CA ERL: COMMENT #103

Bruce Champion, TE

Table 162–16—Cable assembly characteristics summary

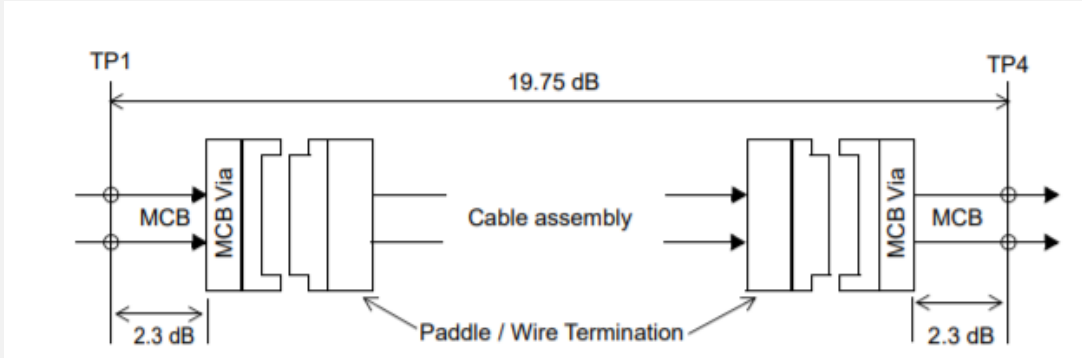
Cable Assembly ERL listed as TBD in Table 162-16

Fill in TBD for CA ERL limit

TBD to be changed to 7.4 dB. See champion_3ck_02_1020.pdf

Replace TBD with 7.4 dB based on champion_3ck_02_1020.pdf slide 6

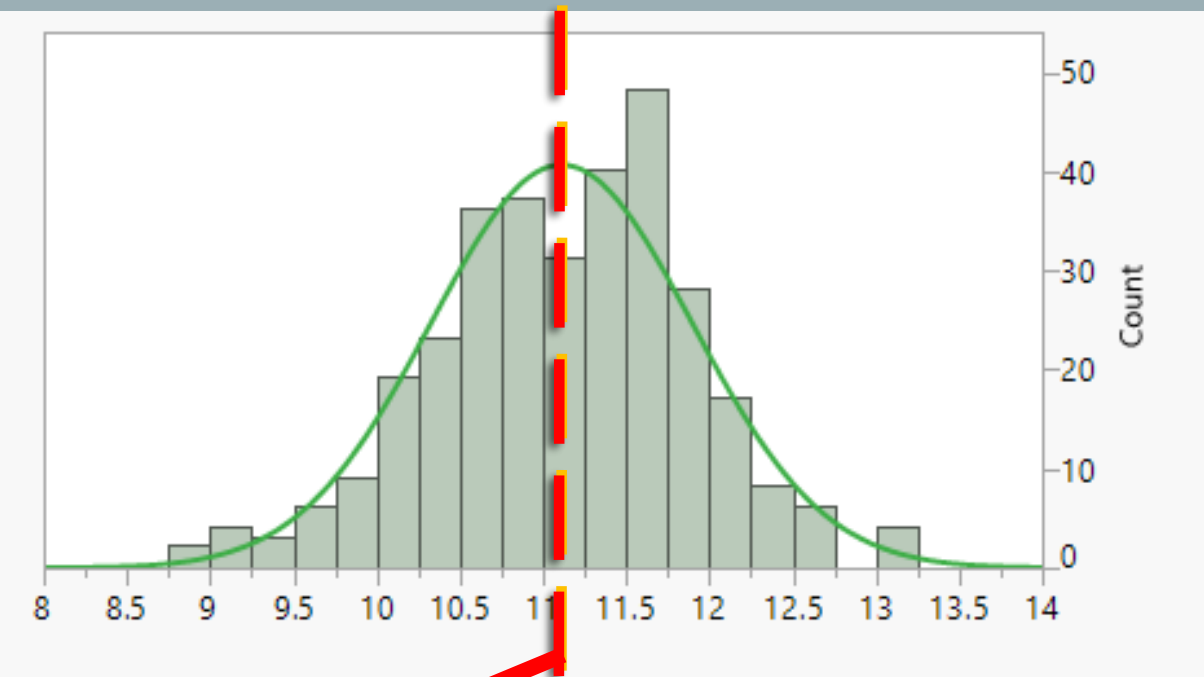
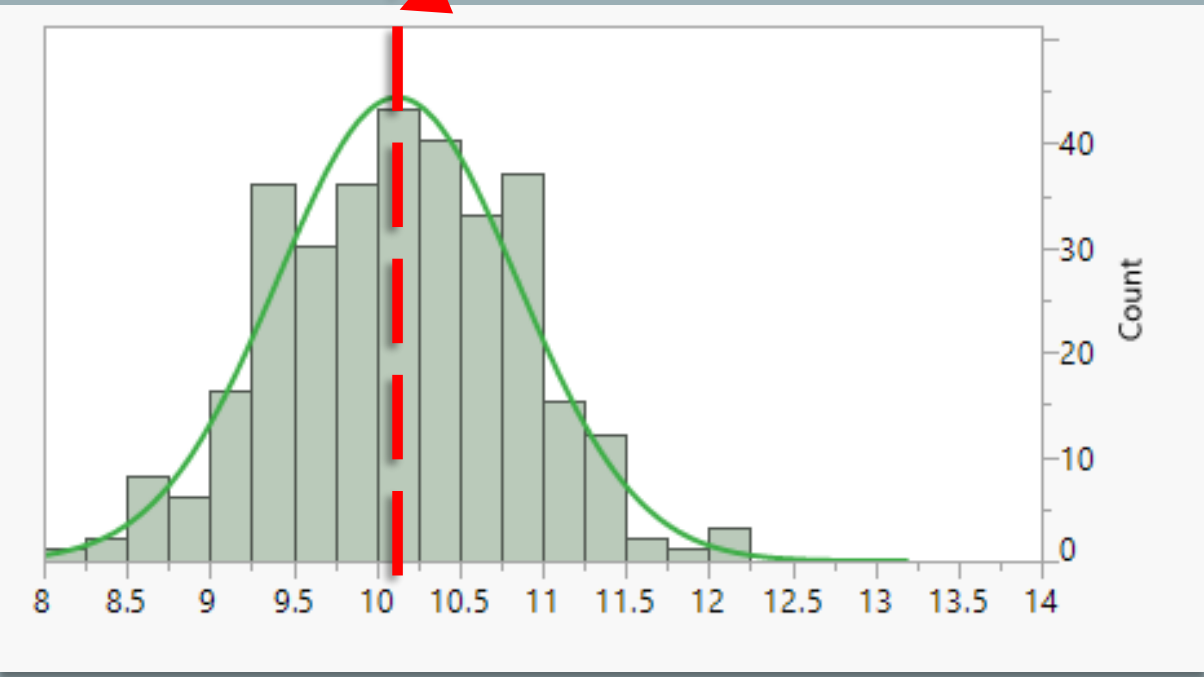
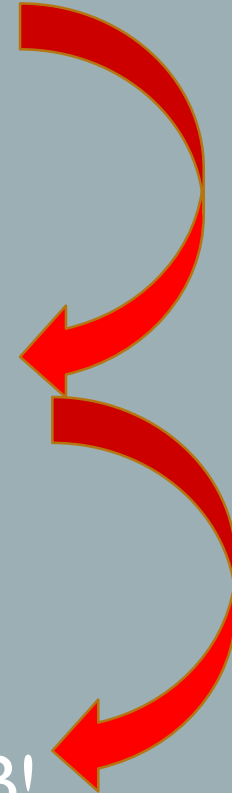
- The way we calculate ERL was modified between COM version 2.93 and 2.95
- This resulted in a reduced ERL value

← The way we calculated ERL in version 2.93

The same exact channels ran through 2.95 version

← The way we calculate ERL in version 2.95
ERL Values are lowered by 1 dB!

Proposed Limit

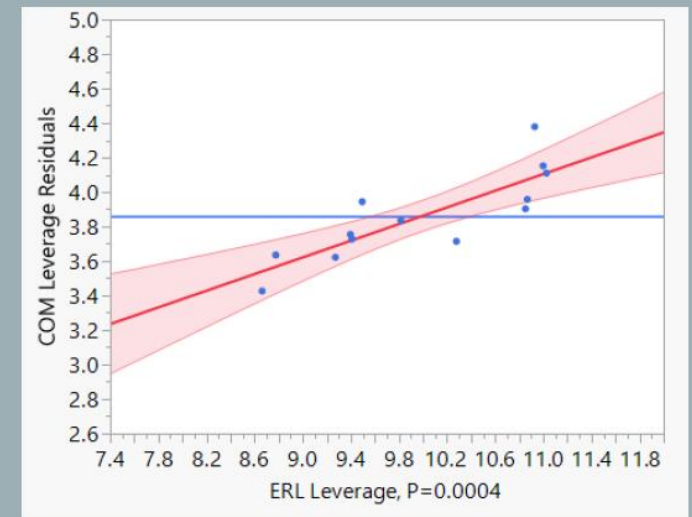
- Same 13 channels from previous slide used
- Relationship between ERL and COM observed
- The linear fit of data is showing:
 - COM = 3 dB at ERL = 6.4 dB
- Looking at the confidence interval:
 - COM = 3 dB at ERL \approx 7.4 dB
 - Using this data, a limit of 7.4 dB for ERL is proposed

ERL Limit moved to different values

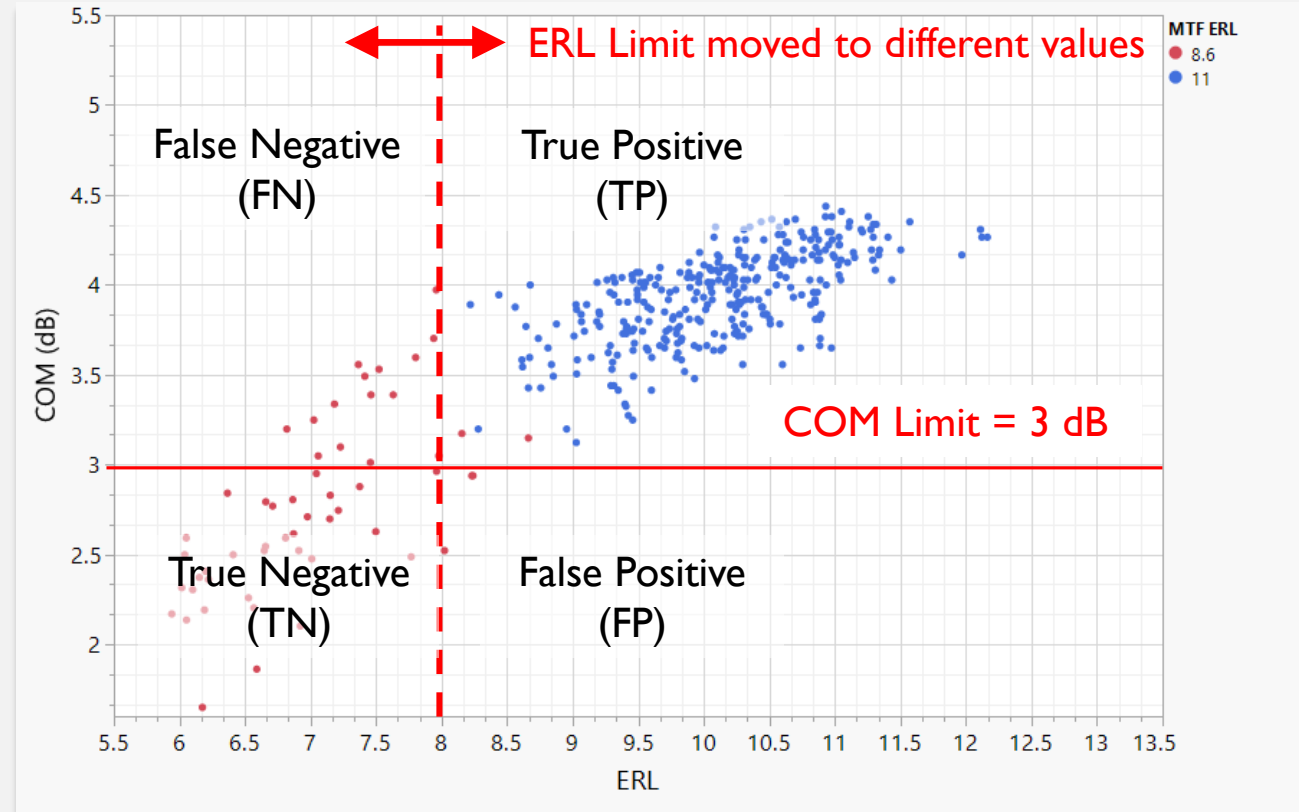
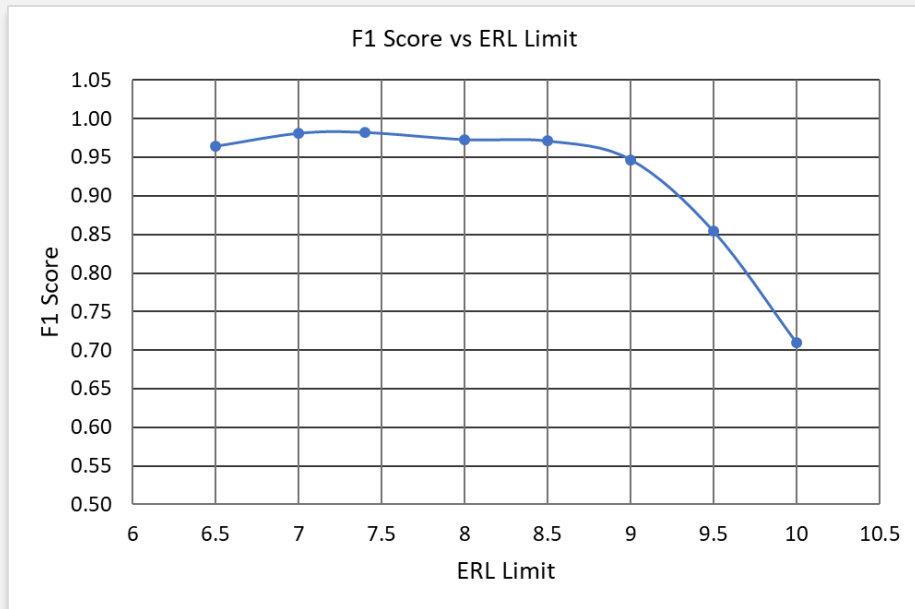
- The data was broken up into a confusion matrix using varying CA ERL Limits
- The higher the F1 score the better balance between recall (False Negatives) and precision (False Positives)

- All of the data shown here is actual measurement data taken on 2m OSFP Assemblies
- Higher CA ERL limits show a dramatic drop in the F1 score
- Data is showing an optimal CA ERL in the **7.4 dB range**
 - Achieves balance between COM and ERL
- Other MDIs such as QSFP-DD have not been taken into consideration for this study
